GIRDWOOD TRAILS PLAN

Public Review Draft – Recommendations for Changes/Edits

RE: GTP Public Review Draft

Recommended Changes

NS1: Virgin Creek Natural Space

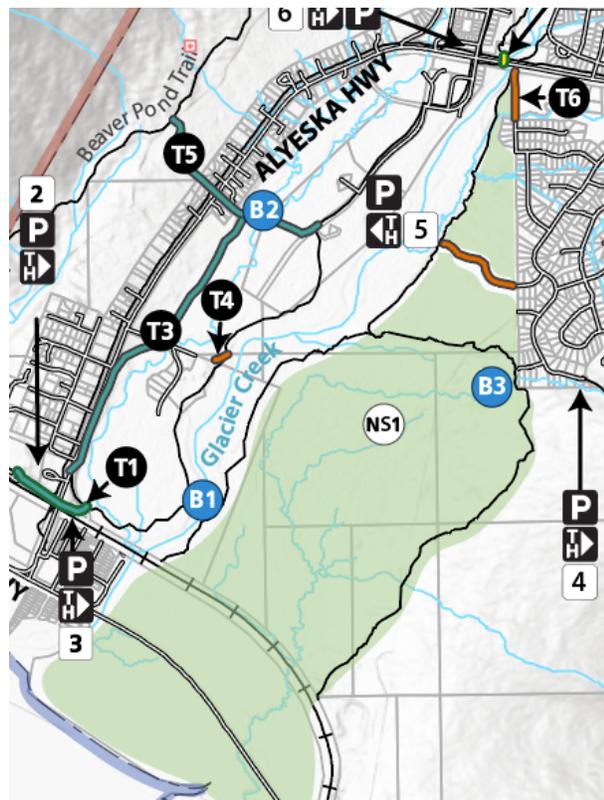
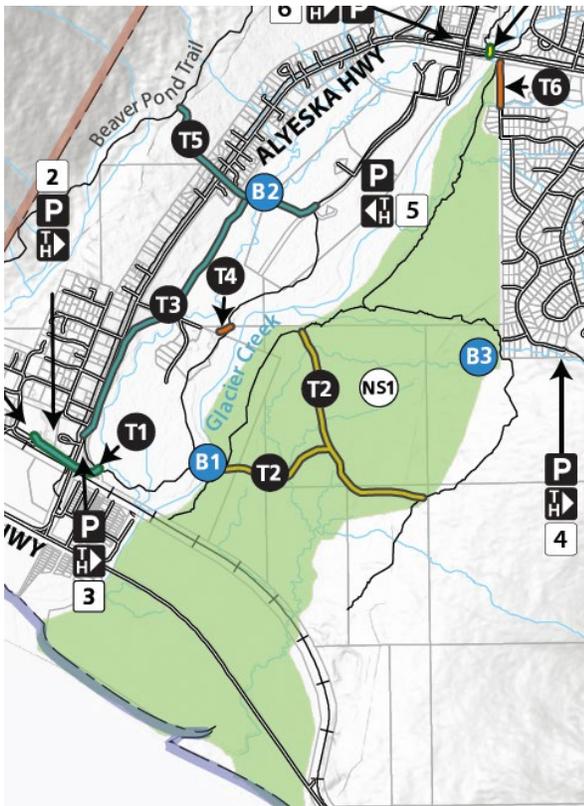
Recommend adjusting the boundary of NS1. The eastern boundary should extend and include the Wagon Trail. The western boundary should be adjusted to remove the Joe Danich Trail from NS1. ADD a trail project to the plan that brings the Joe Danich up to a Class 3 trail constructed to the bicycle design parameter and relocate out of wetlands to uplands. ADD trail project to the plan to construct neighborhood connector trail (Class 3, bicycle design parameters, constructed in uplands) from the Turin and/or Carlina

Drive cul-de-sacs to connect to the Joe Danich trail. NS1, with the adjusted boundary, remains non-mechanized with trails that are no greater than Class 2. Comments indicate that residents want a multi-use alternative trail to connect from the lower valley to the upper valley without using the road system. A Class 3 designation provides a sustainable connection to neighborhoods. The eastern boundary shift better aligns with a primitive experience for the Wagon Trail.

REJECTED

NS2: Stumpy’s Natural Space

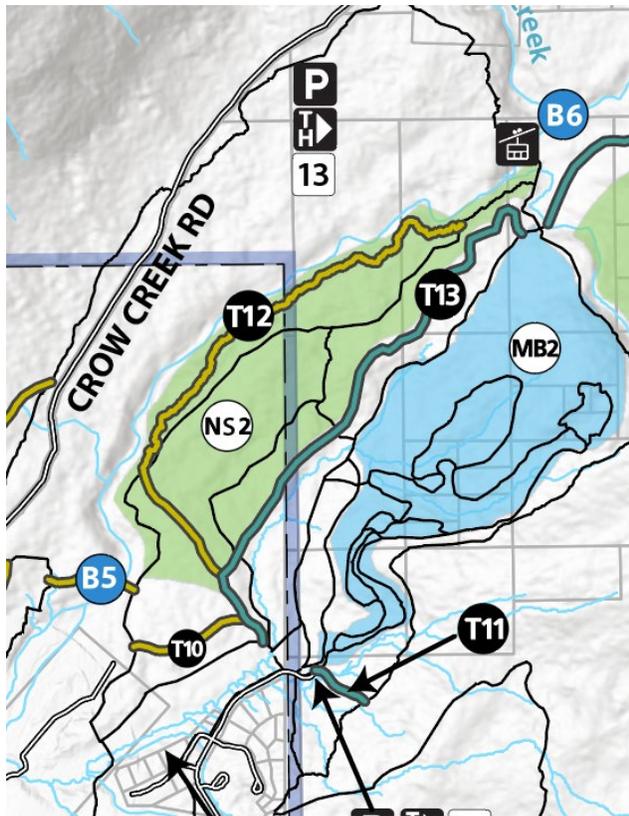
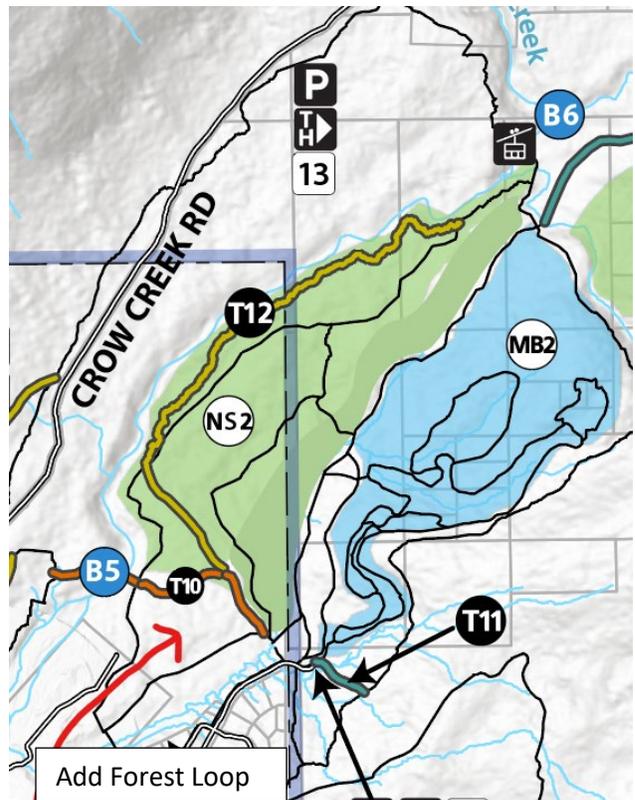
Recommend adjusting the boundary of NS2. Expand the boundary to the east to extend up to but not including the Snowcat Trail and the groomed section of Stumpy’s winter trail. (T13-Upper Valley Multi-Use Trail recommended to be removed from the draft plan and add Forest Loop back).

MB1: Beaver Pond MB Area

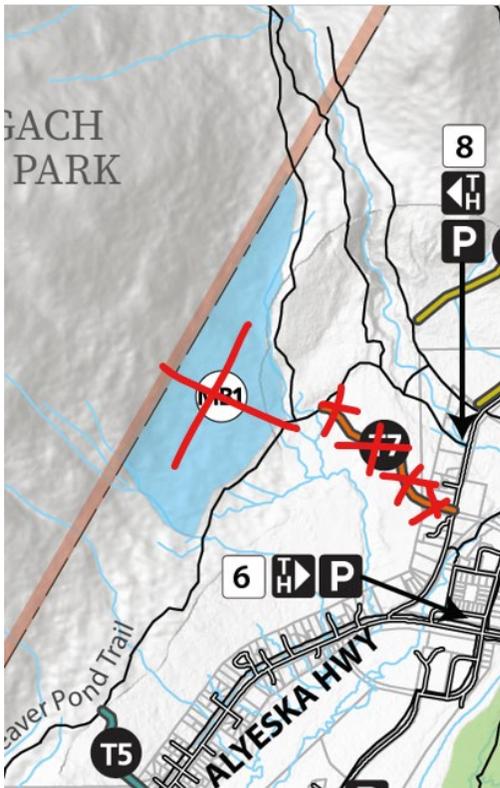
CHANGE RECOMMENDED – Remove MB1 from the plan:

There is not consensus about this project. Needs more discussion – if included in the plan MB1 shall be developed in consultation with the Girdwood Trails Committee only after MB2 is complete. If MB1 is removed, user conflicts on Abe's and California Creek Trails still need to be addressed.

KEEP MB1 in the PLAN

TH 3

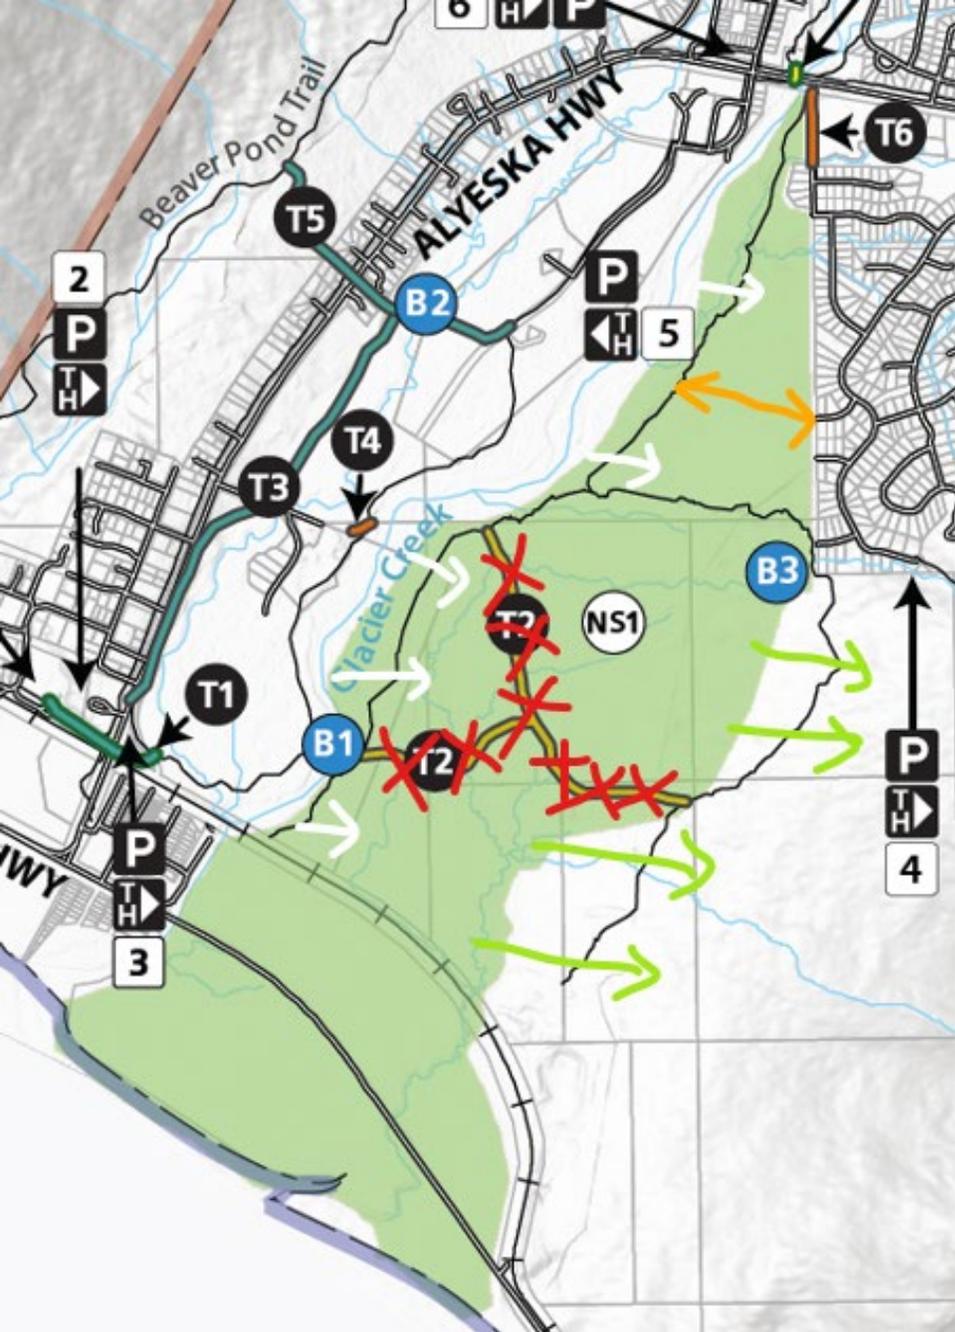
CHANGE RECOMMENDED – Remove this trailhead from the plan.

WHY: Comments indicated there was not public support for this trailhead.

NS1: Virgin Creek Natural Space

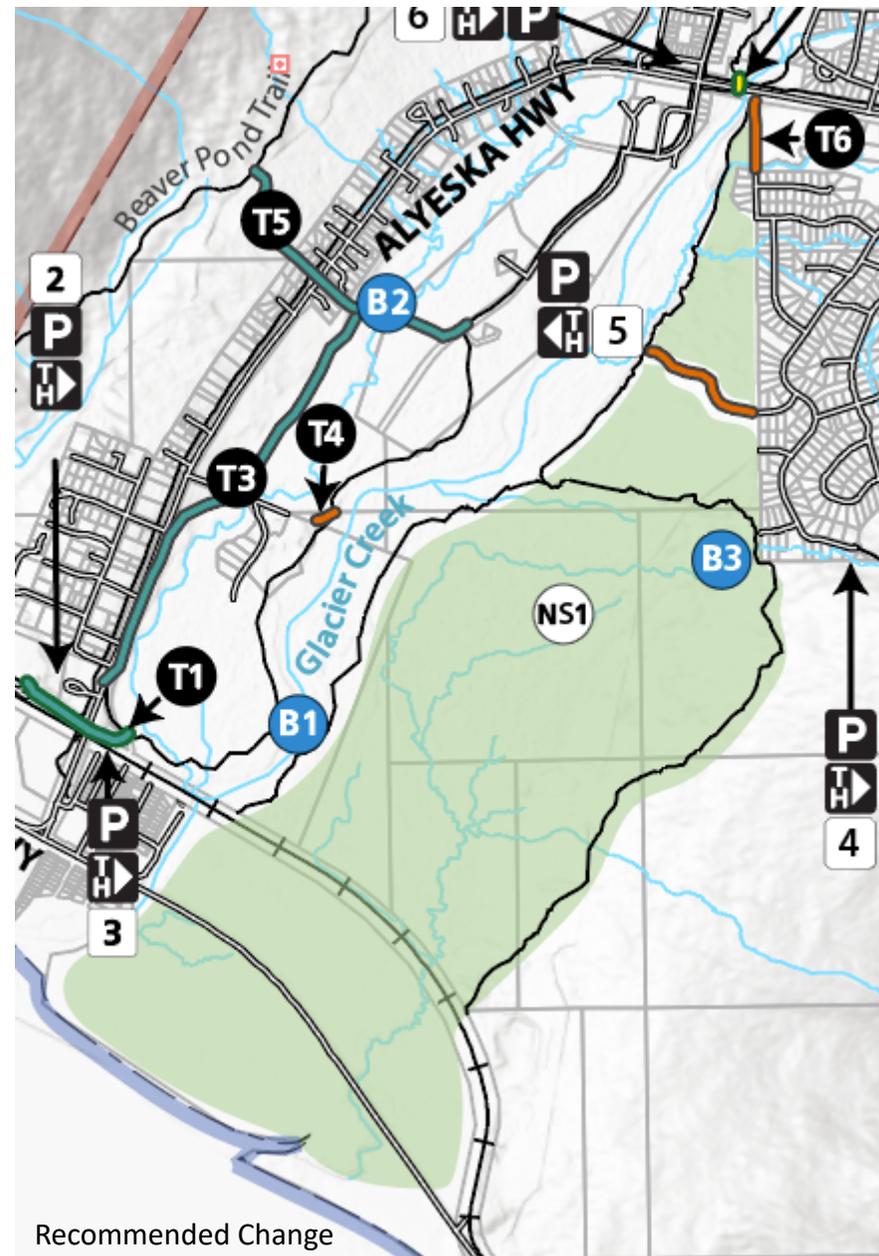
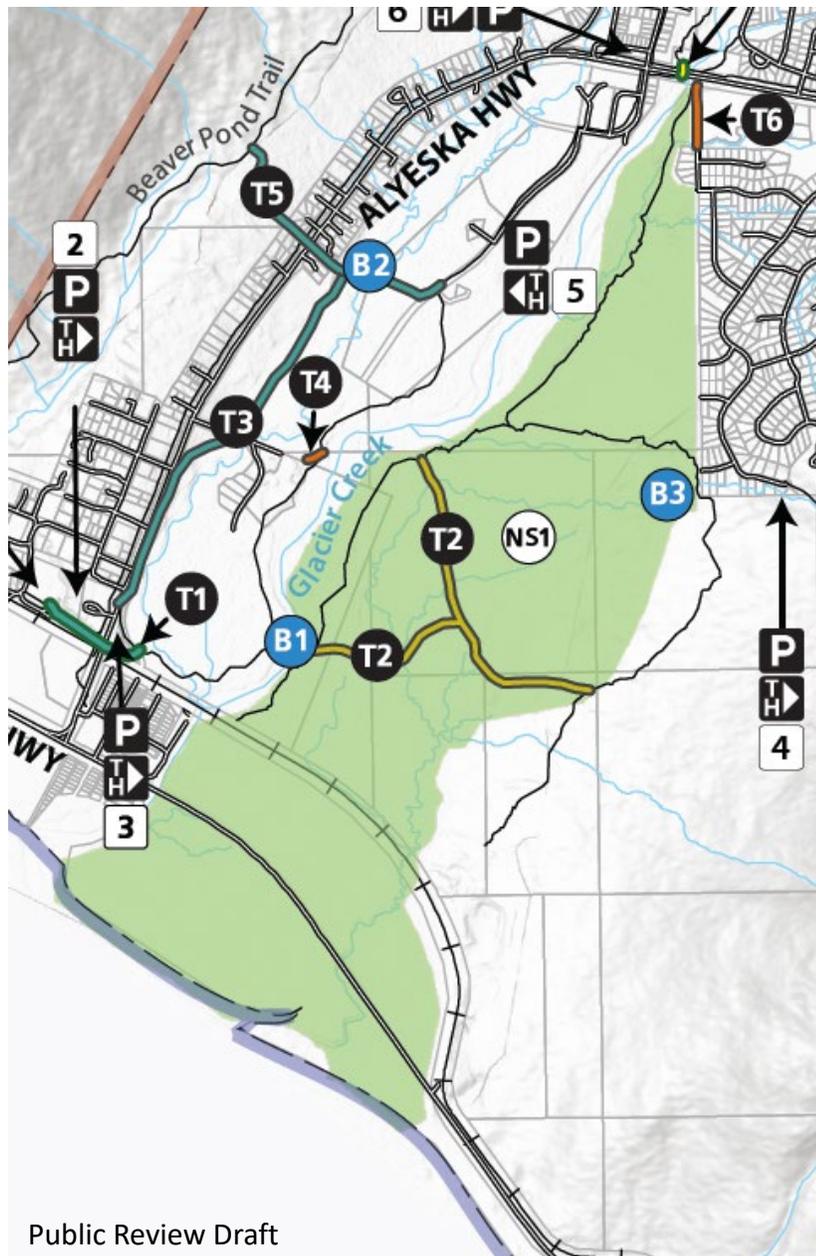
Recommend adjusting the boundary of NS1. The eastern boundary should extend and include the Wagon Trail. The western boundary should be adjusted to remove the Joe Danich Trail from NS1. ADD a trail project to the plan that brings the Joe Danich up to a Class 3 trail constructed to the bicycle design parameter and relocate out of wetlands to uplands. ADD trail project to the plan to construct neighborhood connector trail (Class 3, bicycle design parameters, constructed in uplands) from the Turin and/or Carlina Drive cul-de-sacs to connect to the Joe Danich trail. NS1, with the adjusted boundary, remains non-mechanized with trails that are no greater than Class 2. **WHY:** Comments indicate that residents want a multi-use alternative trail to connect from the lower valley to the upper valley without using the road system. A Class 3 designation provides a sustainable connection to neighborhoods. The eastern boundary shift better aligns with a primitive experience for the Wagon Trail.

MB1: Beaver Pond MB Area

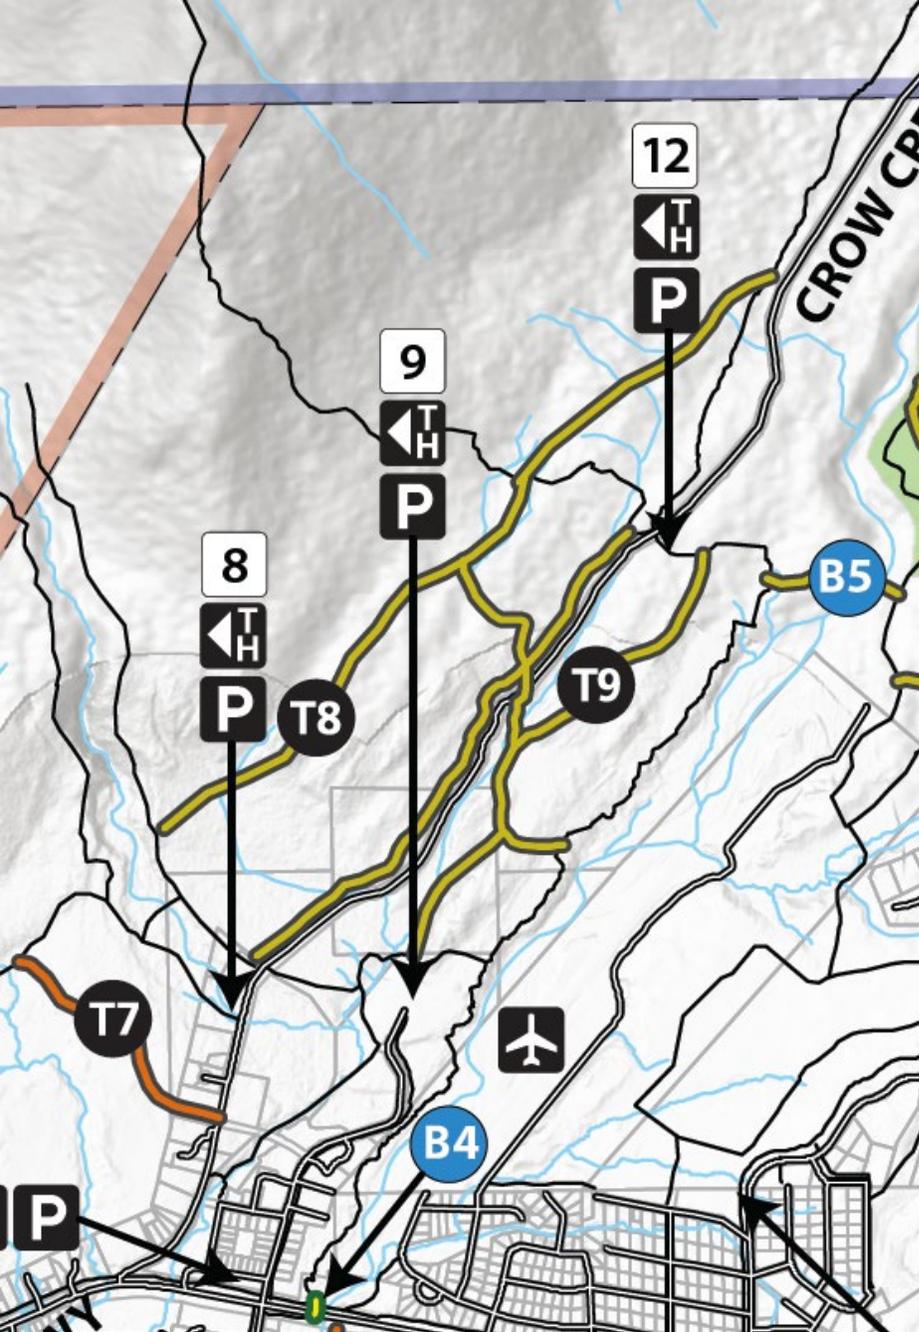
Recommend removing MB1 from the plan. **WHY:** There is not consensus about this project. Needs more discussion – if included in the plan MB1 shall be developed in consultation with the Girdwood Trails Committee only after MB2 is complete. If MB1 is removed, user conflicts on Abe’s and California Creek Trails still needs to be addressed.

NS2: Stumpy’s Natural Space

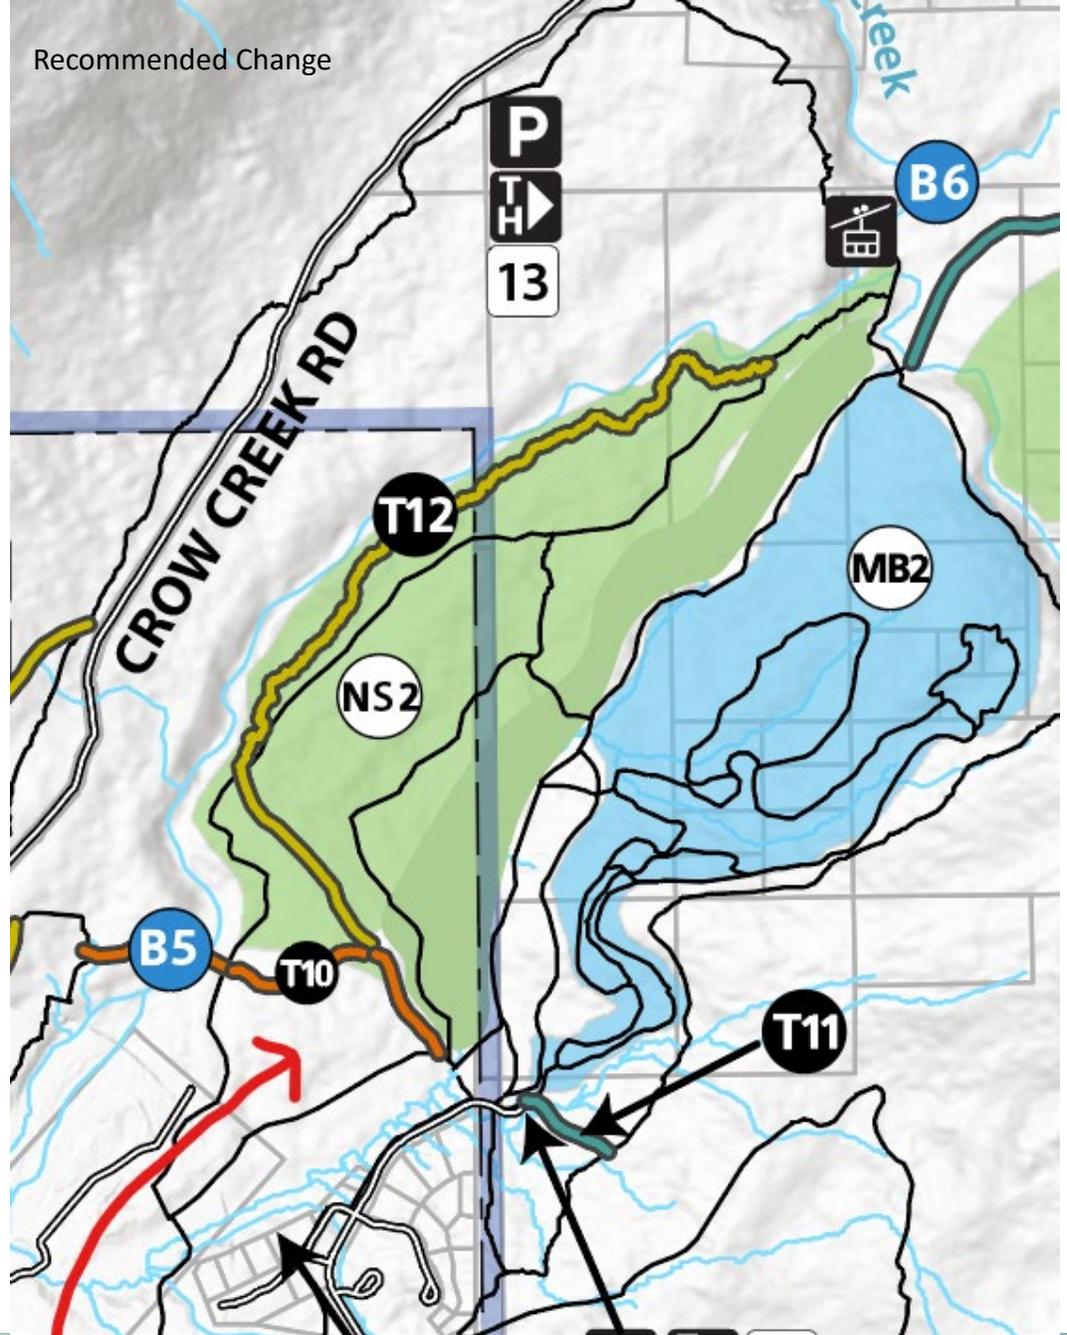
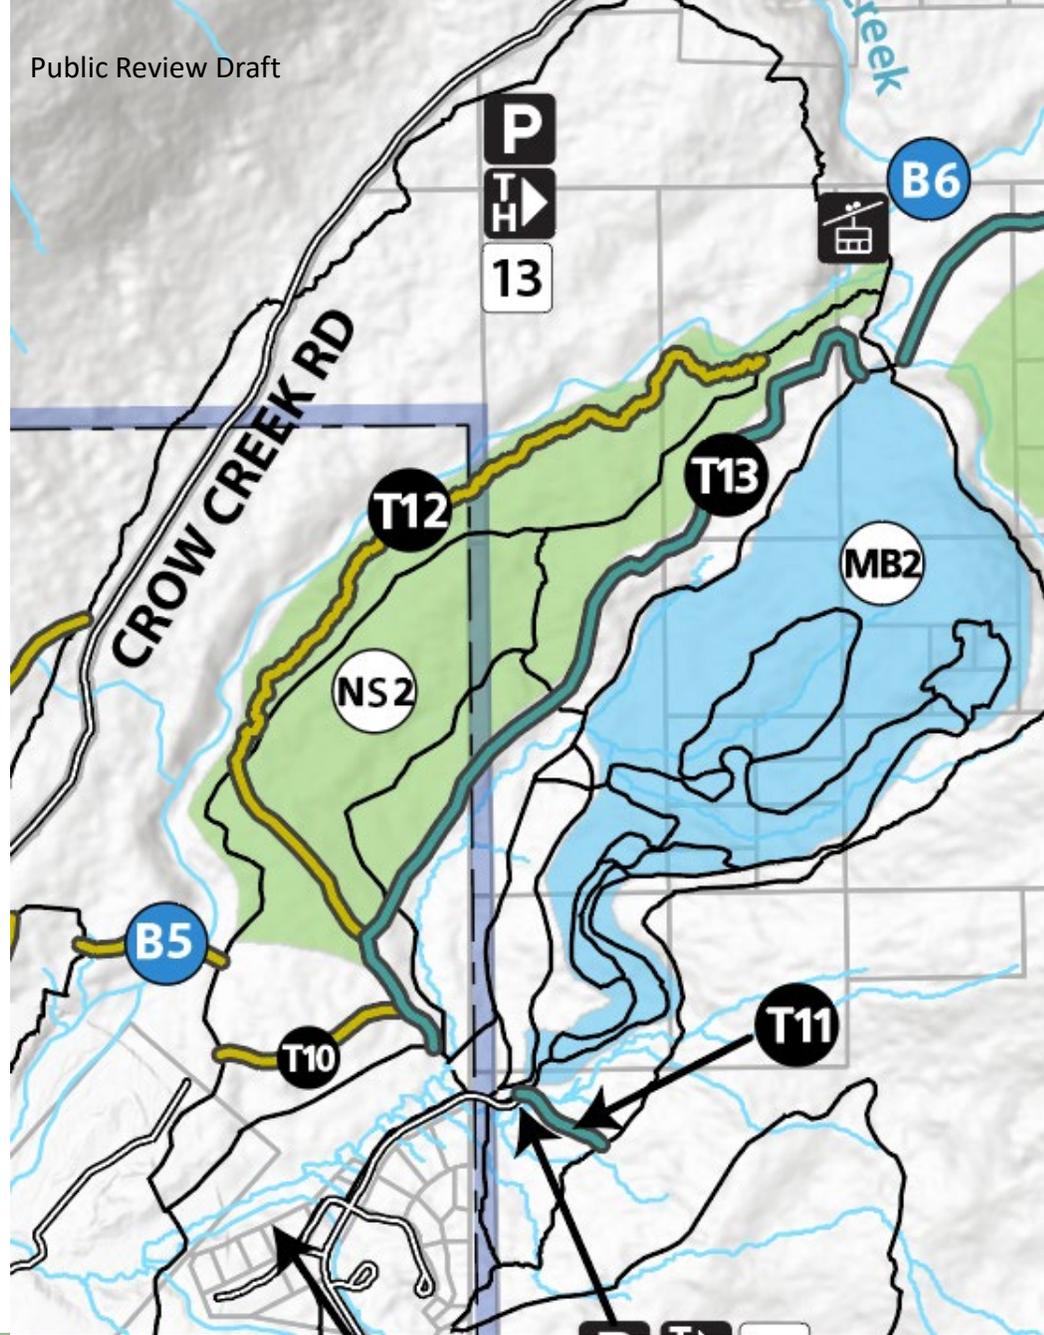
Recommend adjusting the boundary of NS2. Expand the boundary to the east to extend up to but not including the Snowcat Trail and the groomed section of Stumpy’s winter trail. **WHY:** There isn’t consensus for T13 and the wetlands are better suited for a more primitive experience.
